| <b>sabena</b> <sup>®</sup><br><b>B707</b> | Module: COCKPIT + WINDOW | A/C Reg :       | Check :         | <br><b>84G2000001</b> |

DFW B707-24-002 rev 22/05/2007

ALTITUDE ALERTER CB WIRING FROM PHASE B TO C CORRECTION

**FIGURE 1 \_ WIRE MODIFICATION LX-N19997**

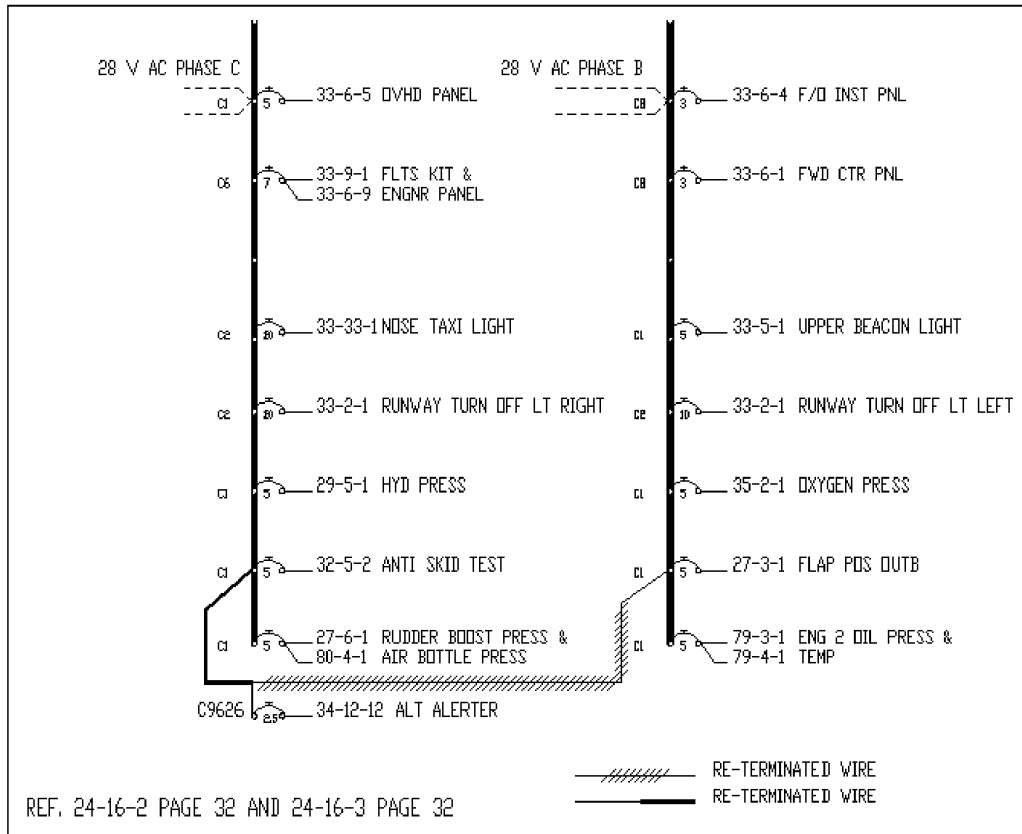
1. Remove electrical power from airplane. Use independent power source for work lights.
2. Gain access to P7 circuit breaker panel. (Ref. AMM 25-4-41)
3. Perform wiring modification as shown in figure 1.
4. Close P7 circuit breaker panel. (Ref. AMM 25-4-41)

P7 WIRING REWORK INSTRUCTION

**FIGURE 2 \_ WIRE MODIFICATION LX-N20000 and LX-N20199**

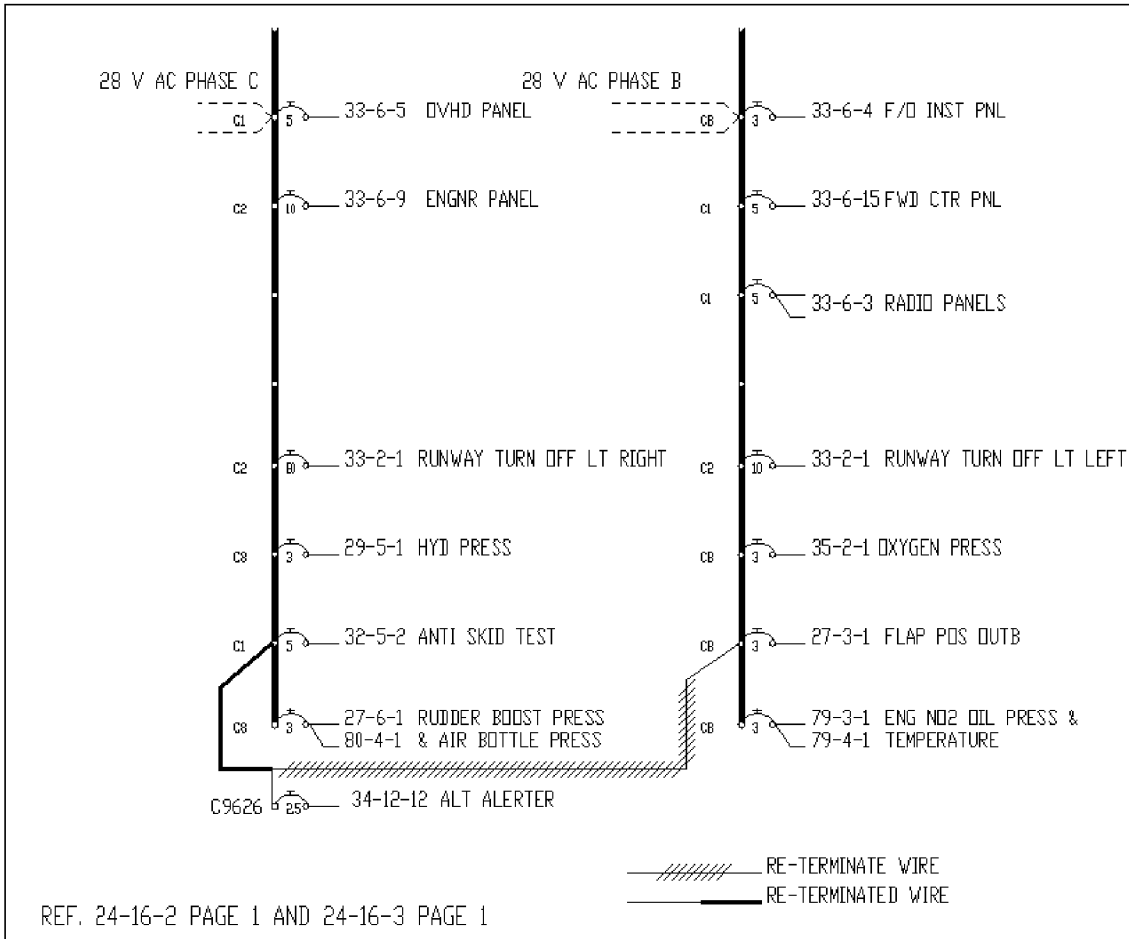
1. Remove electrical power from airplane. Use independent power source for work lights.
2. Gain access to P7 circuit breaker panel. (Ref. AMM 25-4-41)
3. Perform wiring modification as shown in figure 2.
4. Close P7 circuit breaker panel. (Ref. AMM 25-4-41)

P7 WIRING REWORK INSTRUCTION
